CUT PATTERN	
BACK FRAME NO.	
BASE FRAME NO.	
WOOD PATTERN

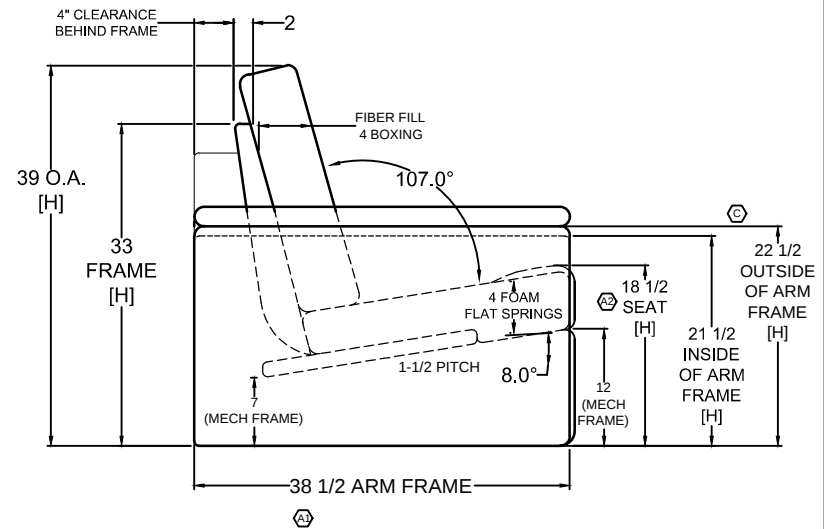
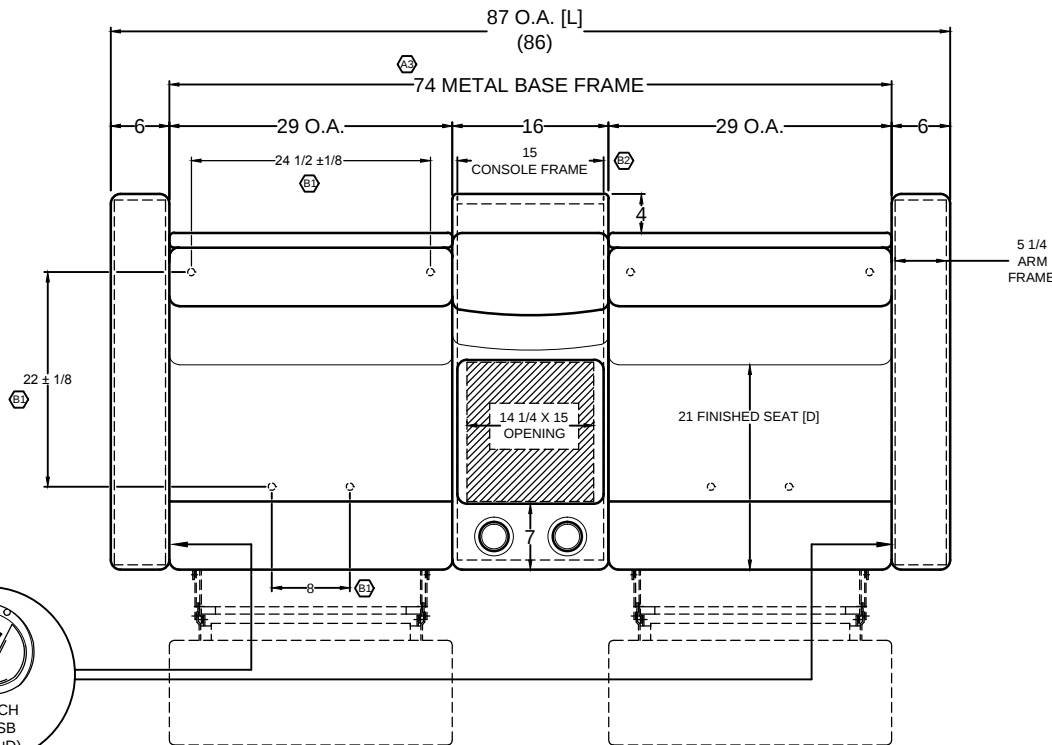
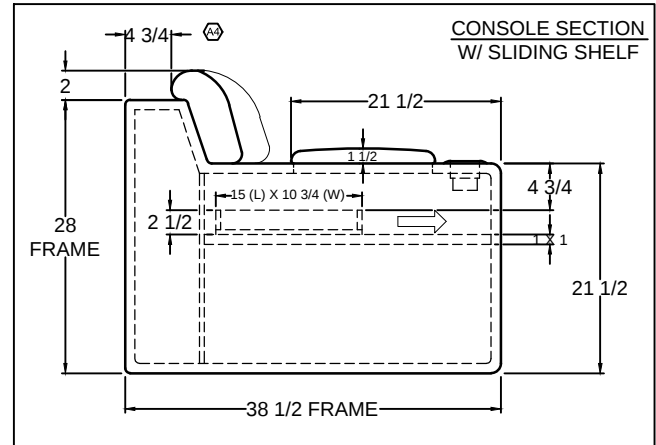
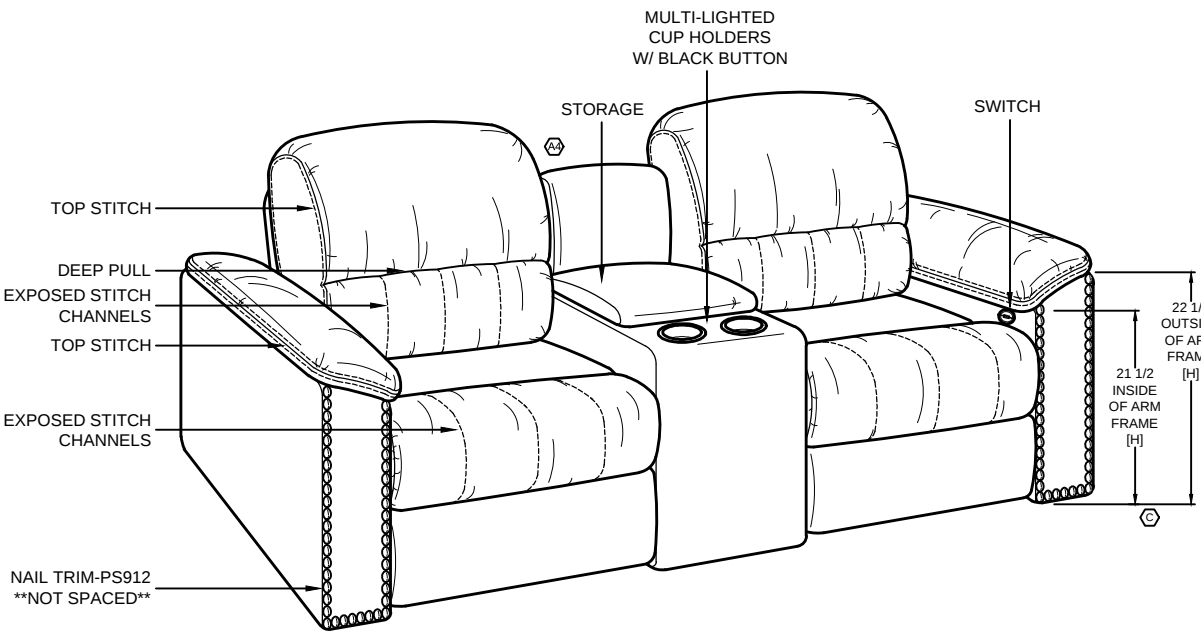
JA	C	WOOD UPDATE: ADDED INSIDE AND OUTSIDE ARM FRAME HEIGHTS. 21-1/2" INSIDE AND 22-1/2" OUTSIDE.	02.01.19
JA	B	METAL UPDATE: [1] CHANGE TO BOLT TABS & ADD DIMENSIONS WOOD UPDATE: [2] CHANGE CONSOLE FRAME WIDTH TO 15"; WAS 15-1/4".	01.31.19
JA	A	PRODUCTION UPDATE: [1] REMOVED O.A. DEPTH AND CHANGED O.A. DEPTH TO 38-1/2"; WAS 38". [2] CHANGED SEAT HEIGHT TO 18-1/2"; WAS 18". [3] ADDED 74" METAL BASE FRAME WIDTH DIMENSION TO DRAWING. [4] ADDED BACK FRAME AND PILLOW TO CENTER CONSOLE.	01.16.19
